## **Canada HCR 2.0 Card Reader Requirements** **(Canada Only!)**

### **Related Equipment:**

- Advantage
- Encore 300/Encore 500
- Encore 500 S ECIM
- OPT

### **Reason for Bulletin:**

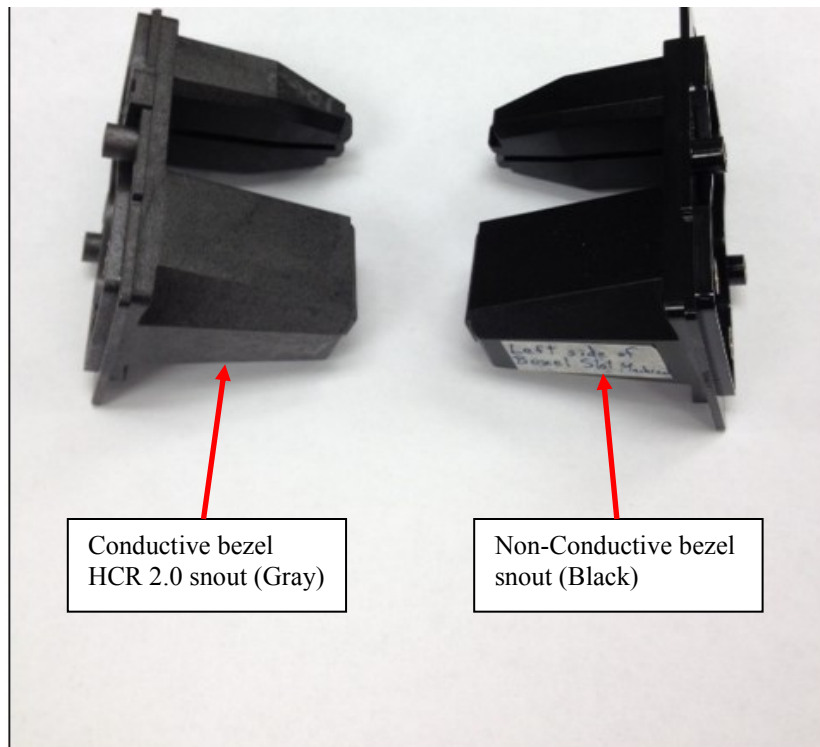
Starting immediately for all **Suncor** locations (Until further notice) when an HCR 2.0 Card Reader is being installed or replaced you should do the following:

- Priority #1: Install Card Reader part # M12492B101 (14.4 /Conductive)
- Priority #2: Install Card Reader part # M12492B121 (14.4 /Conductive)
- Priority #3: Leave fueling position out of order
- **DO NOT USE A M12492B022 UNDER ANY CIRCUMSTANCE!!!**
